*PLANS FOR THE CONSTRUCTION OF
SEDIMENT REMOVAL
FOR
VITRUVIAN PARK
TOWN OF ADDISON, TEXAS
PUBLIC WORKS #19-77*

VITRUVIAN PARK
 DREDGING
 TOWN OF ADDISON
 DALLAS COUNTY, TEXAS

revisions	date
1 ADDENDUM 3	2/20/2019

MAIN CHANNEL CROSS SECTIONS					Sheet No.
design	drawn	checked	scale	date	13
NDM	NDM	NDM	NDM	2/20/19	22
NDM job number					18-005

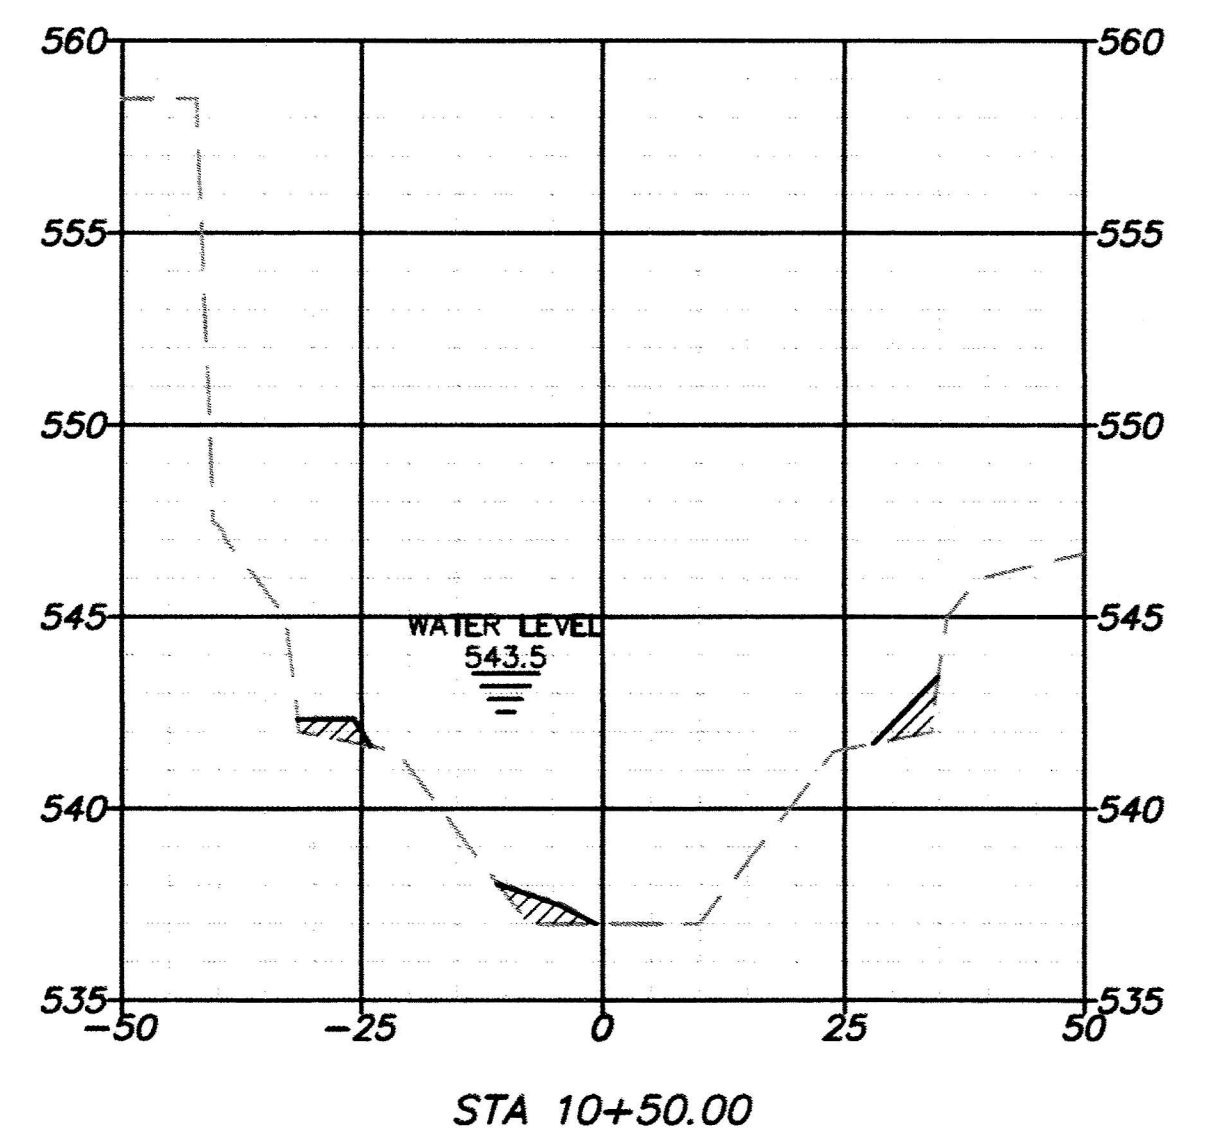
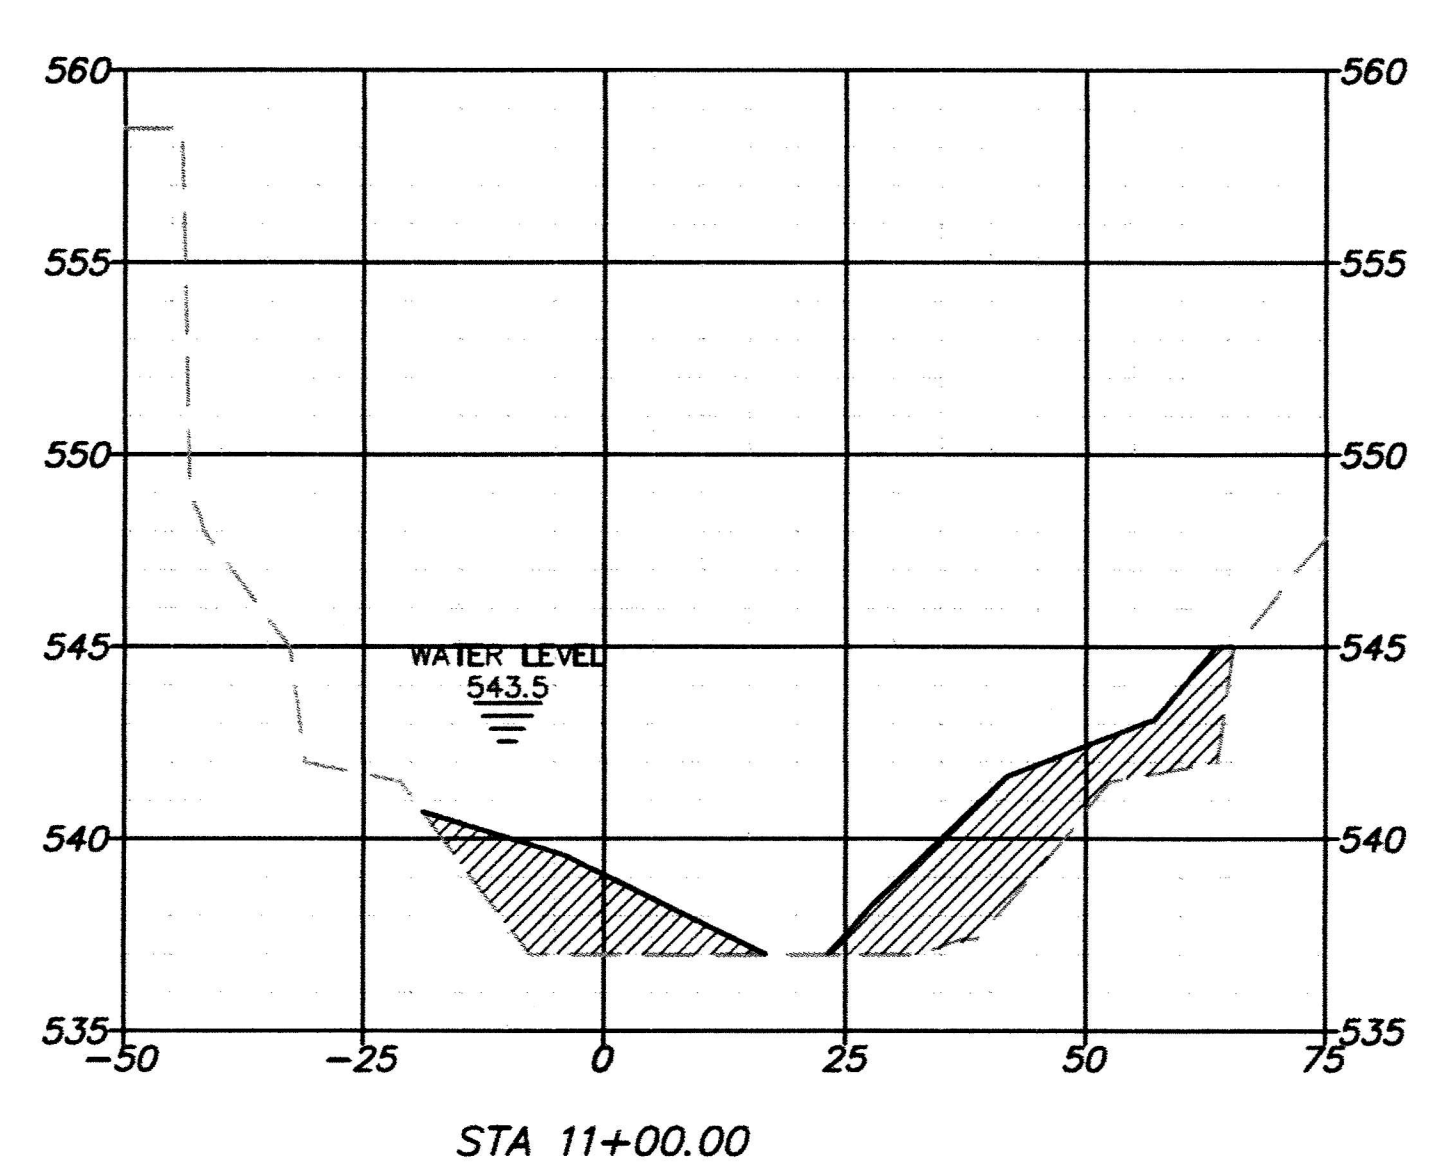
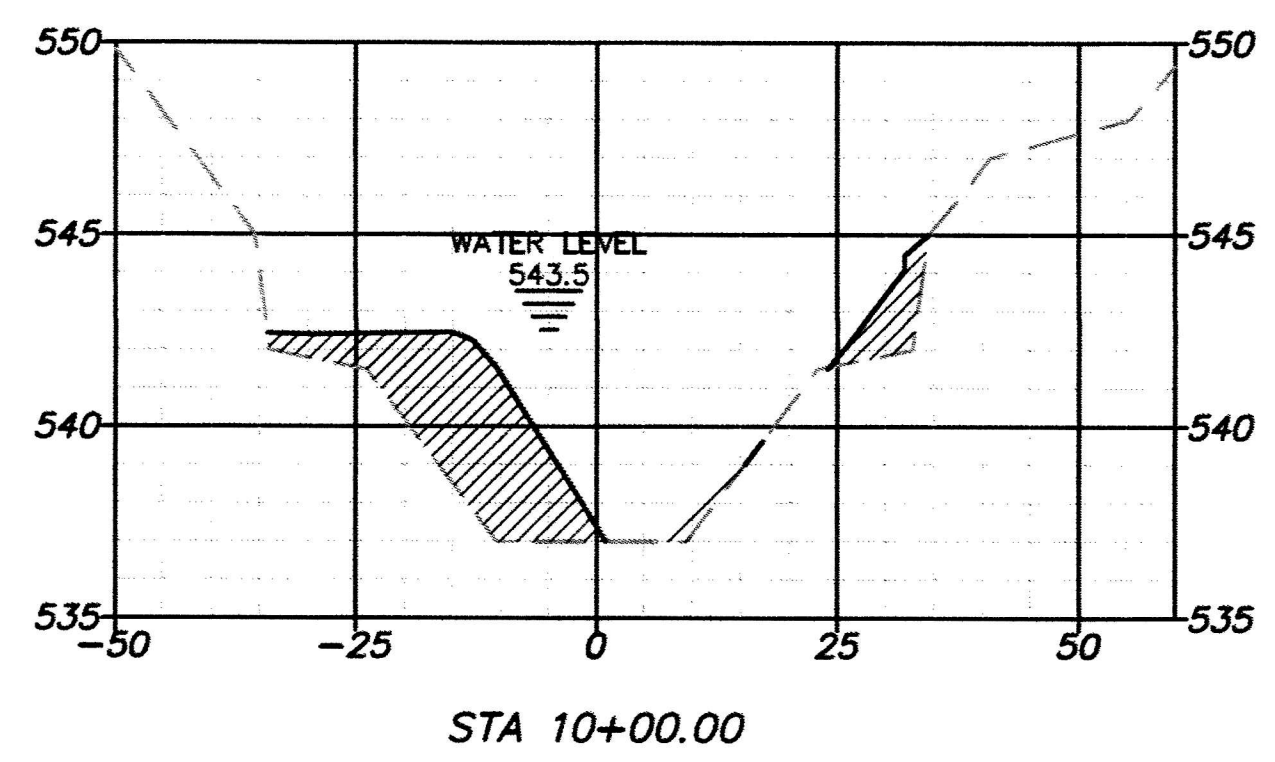
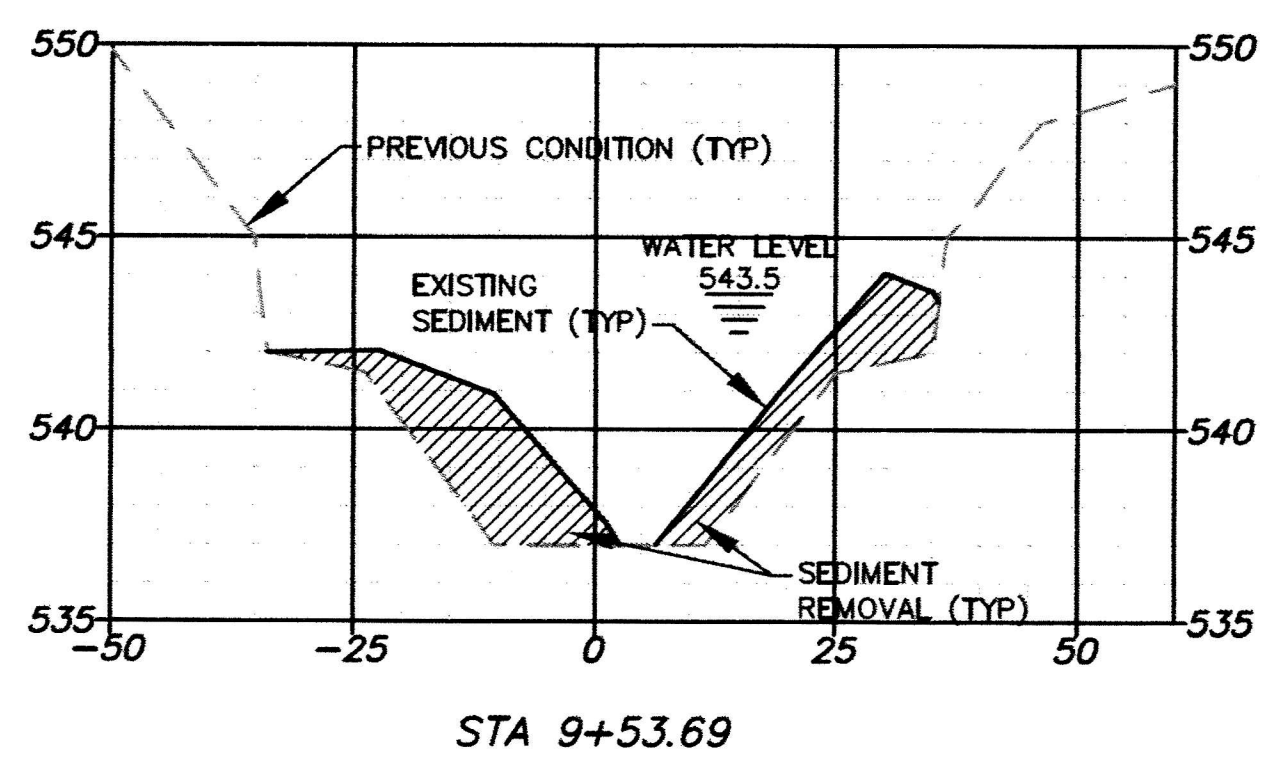
▲ WATER SURFACE ADDED BASED ON SURVEY OF 2/18/2019.

MAIN CHANNEL CROSS SECTIONS				
design	drawn	checked	scale	date
NDM	NDM	NDM	NDM	2/20/19

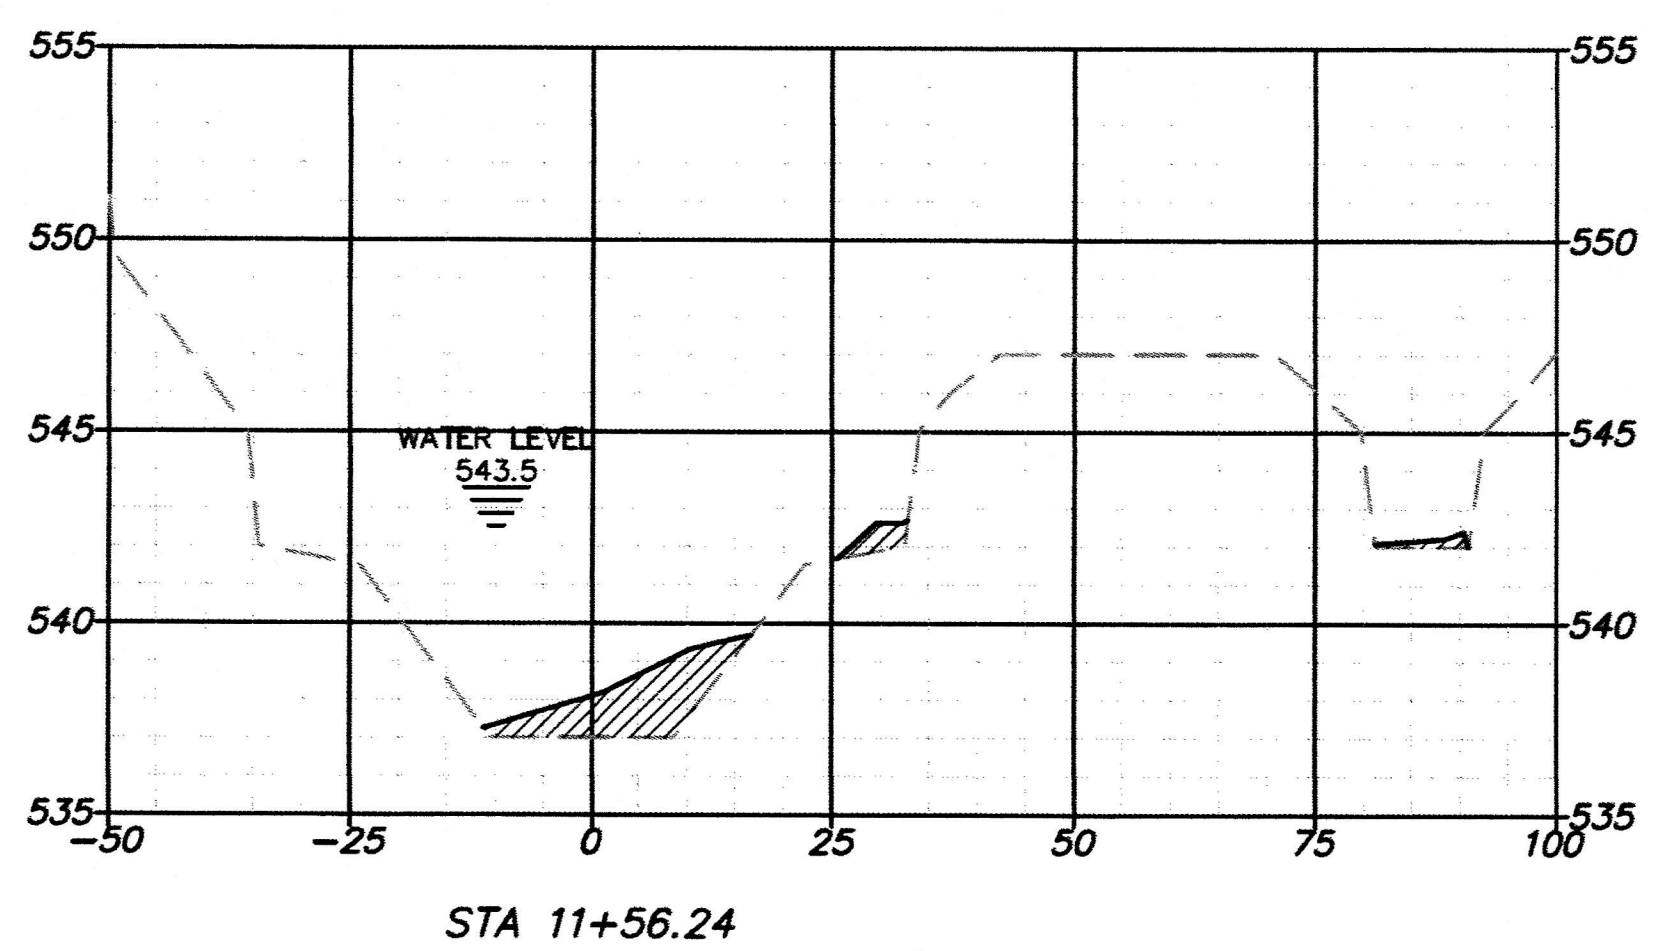
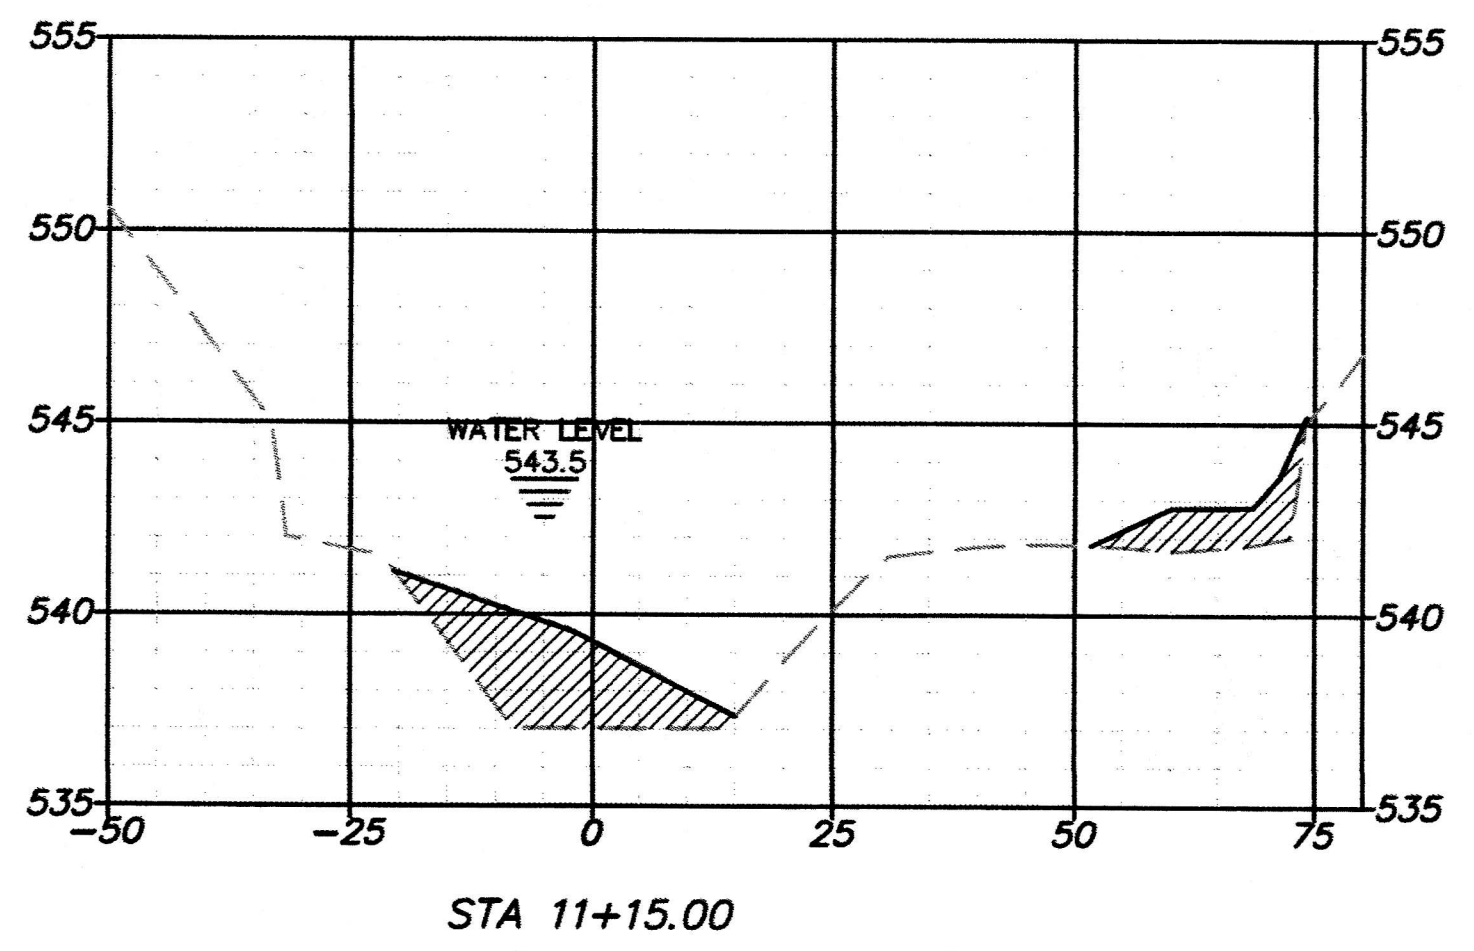
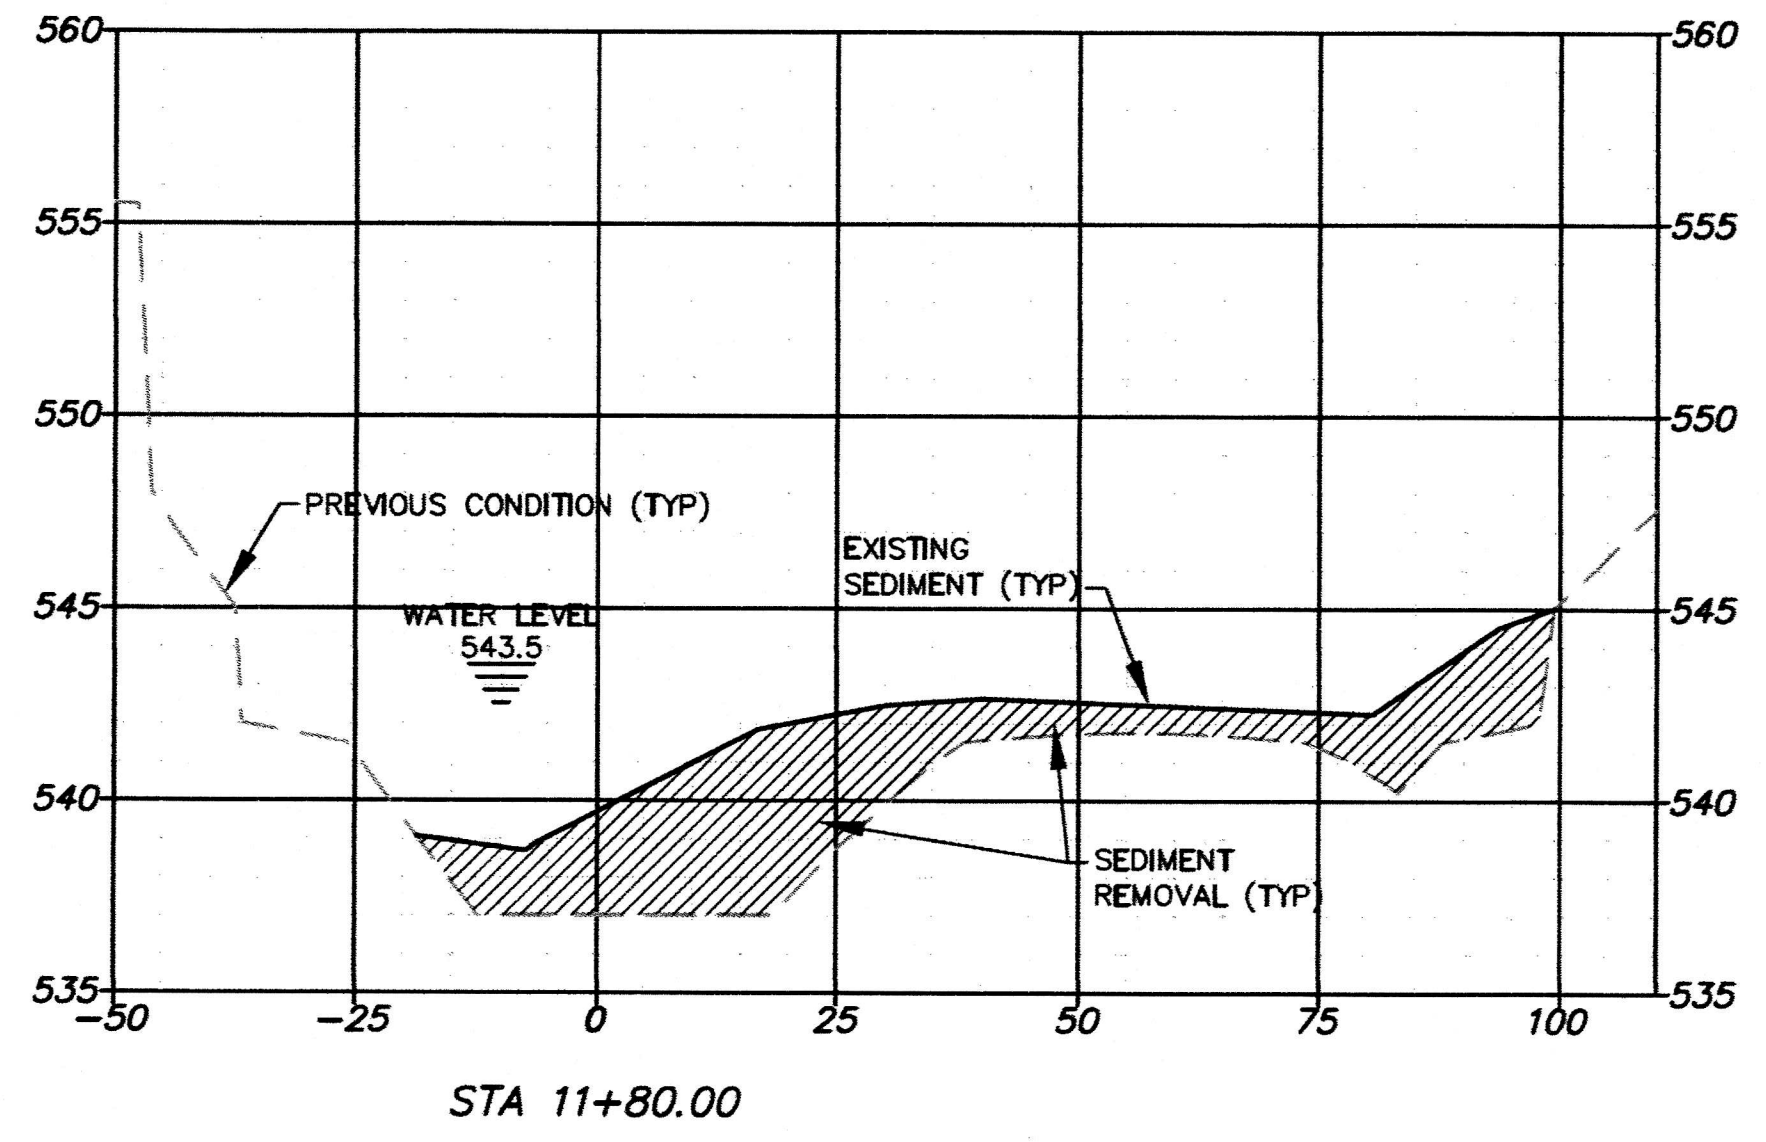
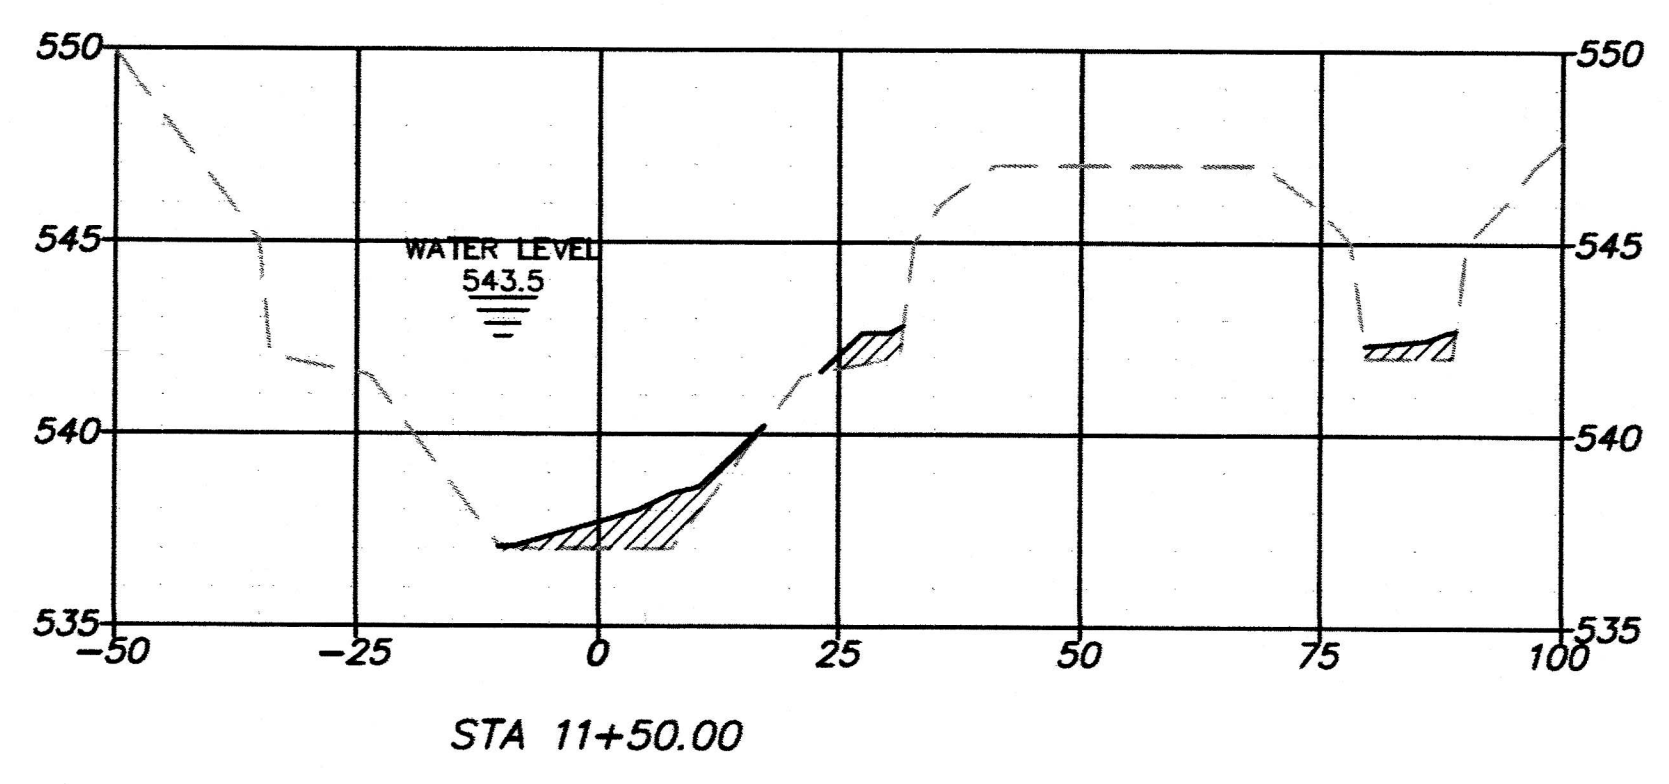
▲ WATER SURFACE ADDED BASED ON SURVEY OF 2/18/2019.
